Proposed Change Orders for November 2024

BG #21-072 New Stanton Elementary School

Powell County Board of Education

Attachment: Plugmold Detail

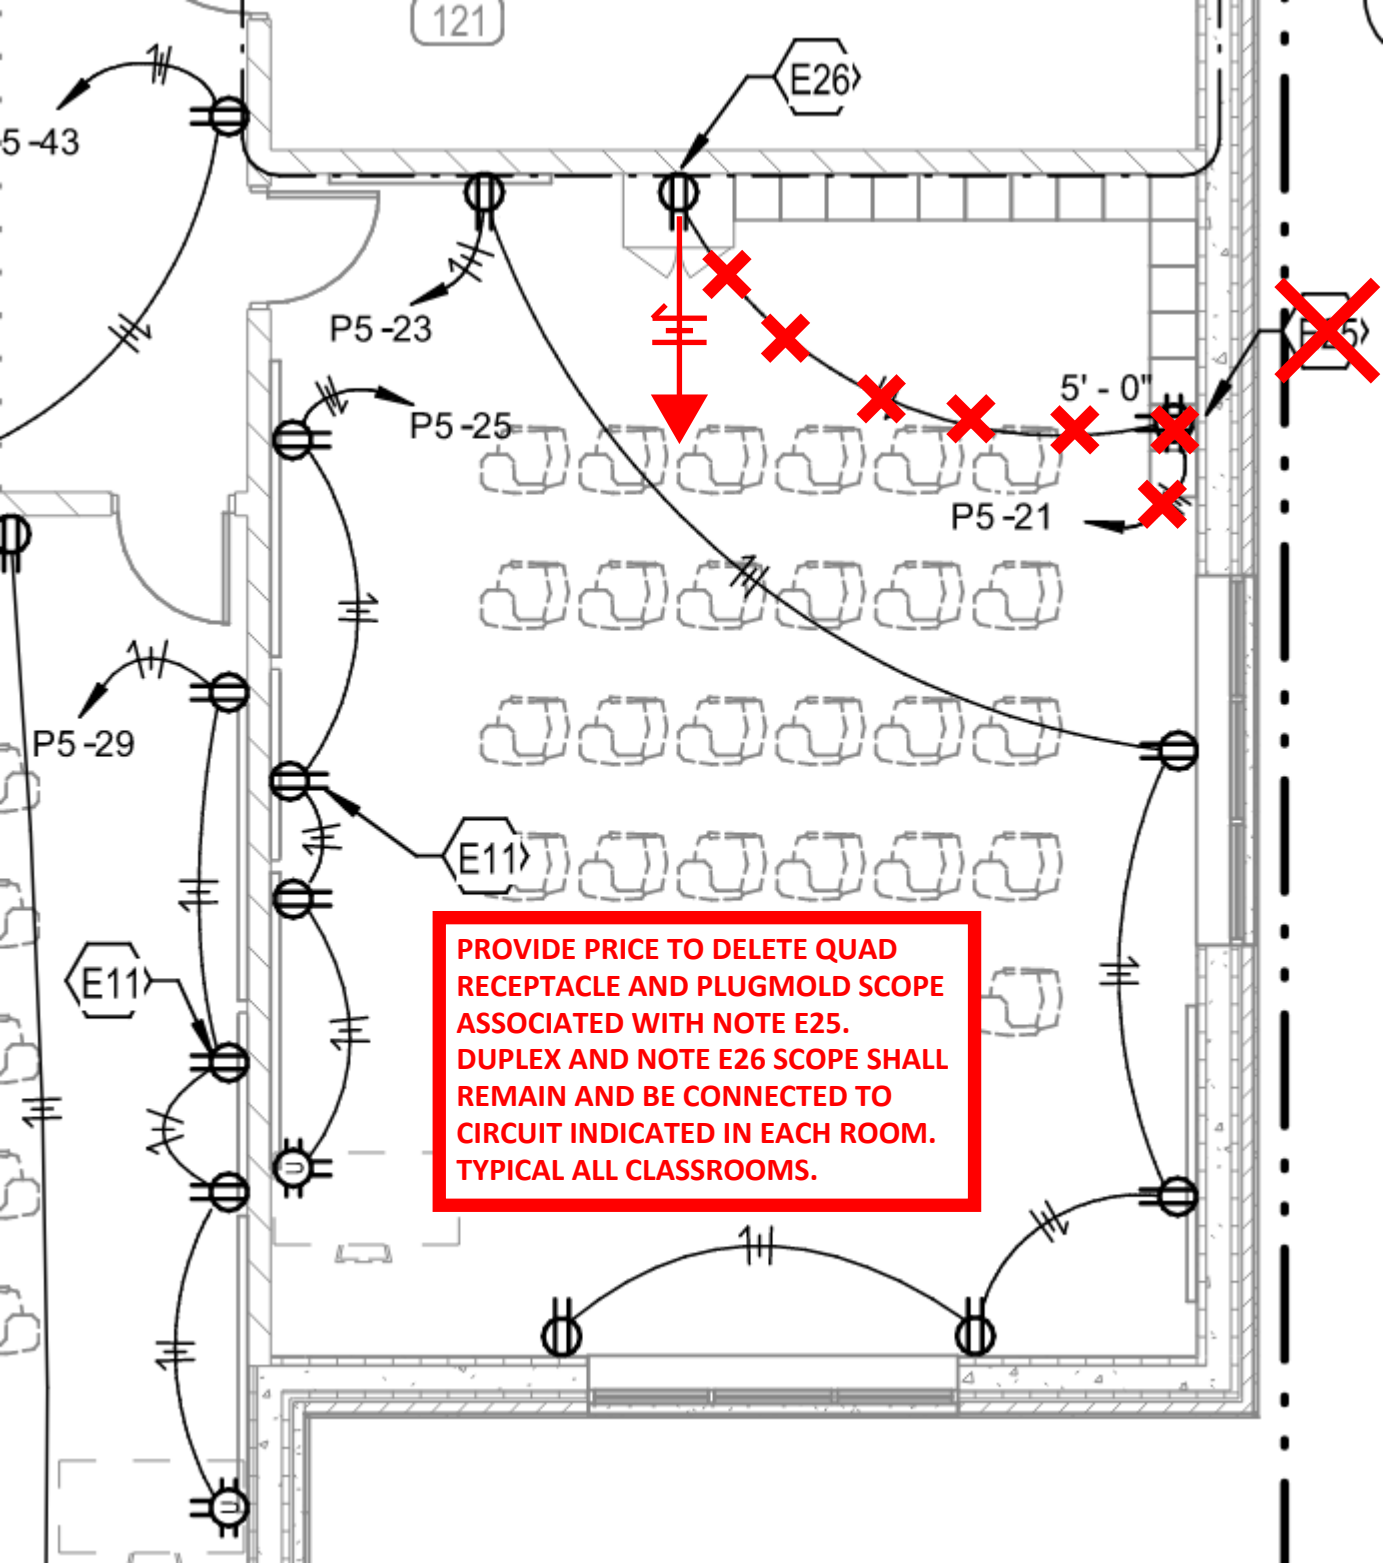
Provide itemized credit pricing for labor and material to omit the plug mold along the top of the cubbies and quad outlets behind upper cabinets in all Classrooms per the attached document.

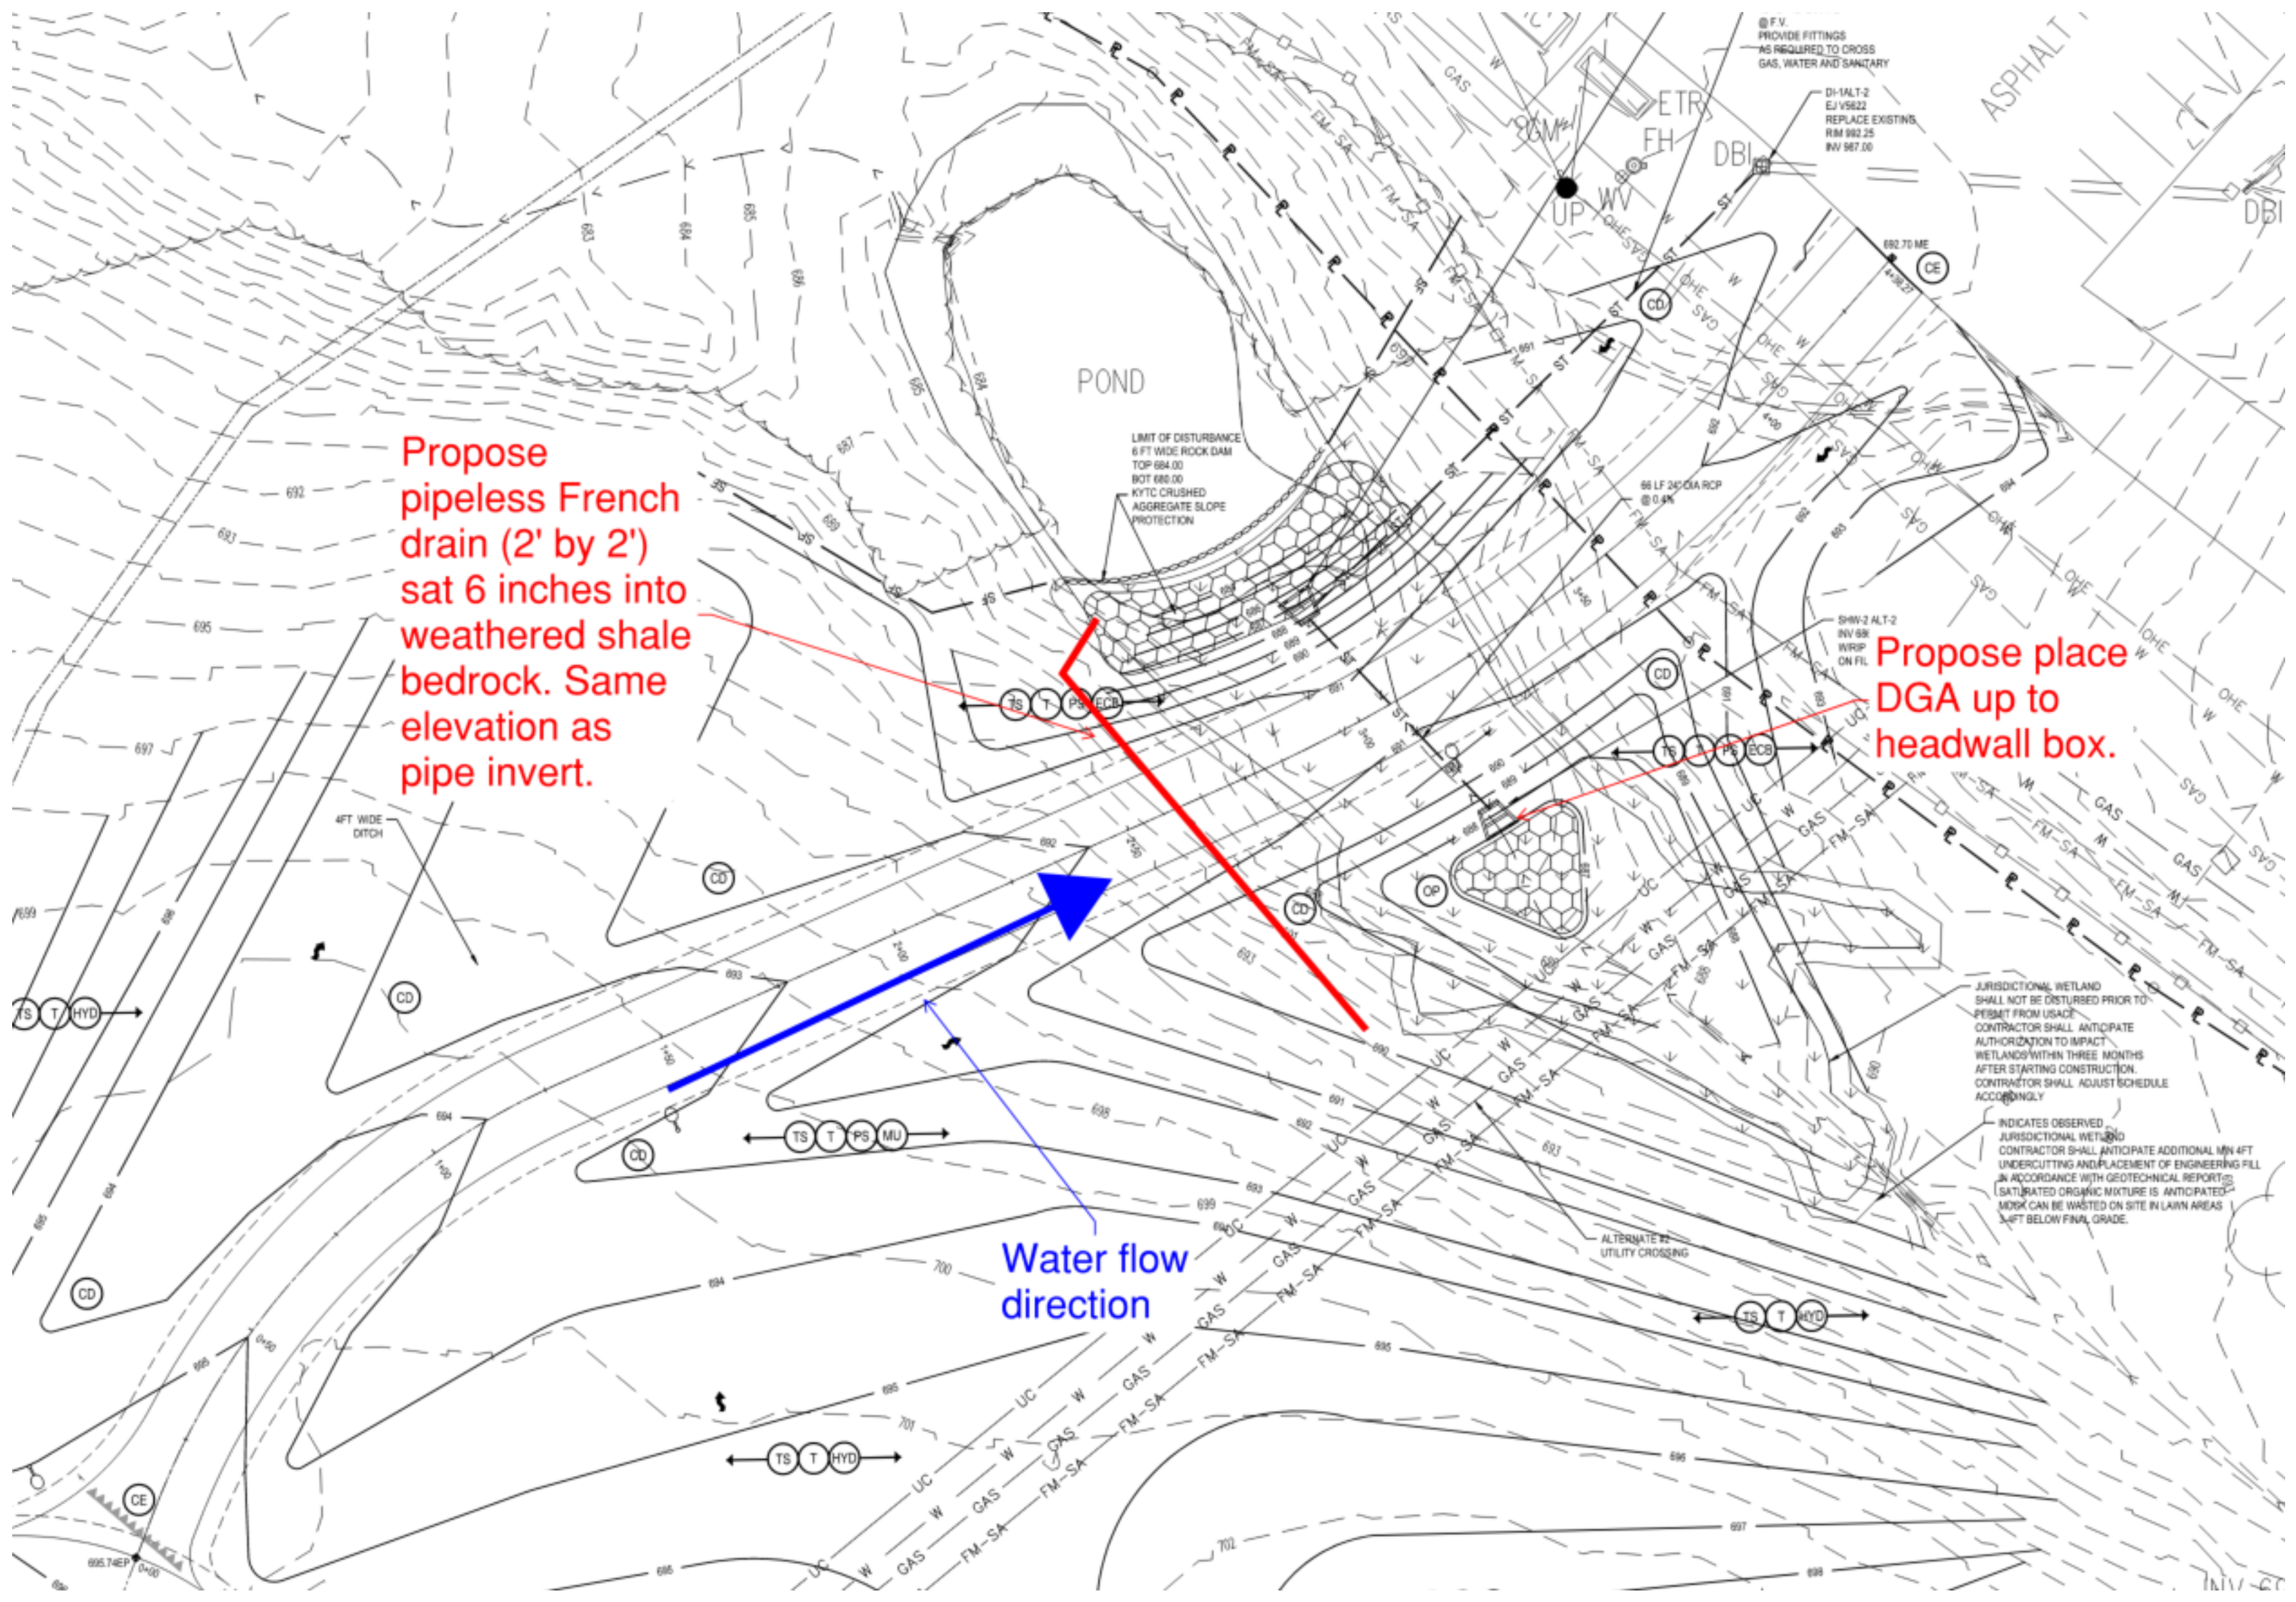
Solid Ground is recommending that a pipeless French drain be installed up slope from the wetlands starting at the same elevation of the under-road pipe invert. The French drain should be dug and set into the weathered bedrock a minimum of 6 inches. The French drain should be roughly 2 feet by 2 feet and filled with a fabric wrapped open graded stone (#57 or similar). In addition, to help with setting and long-term performance of the headwalls, we recommend that the backfill material under the headwalls with DGA.

Propose pipeless French drain (2' by 2') sat 6 inches into weathered shale bedrock. Same elevation as pipe invert.

Propose place DGA up to headwall box.
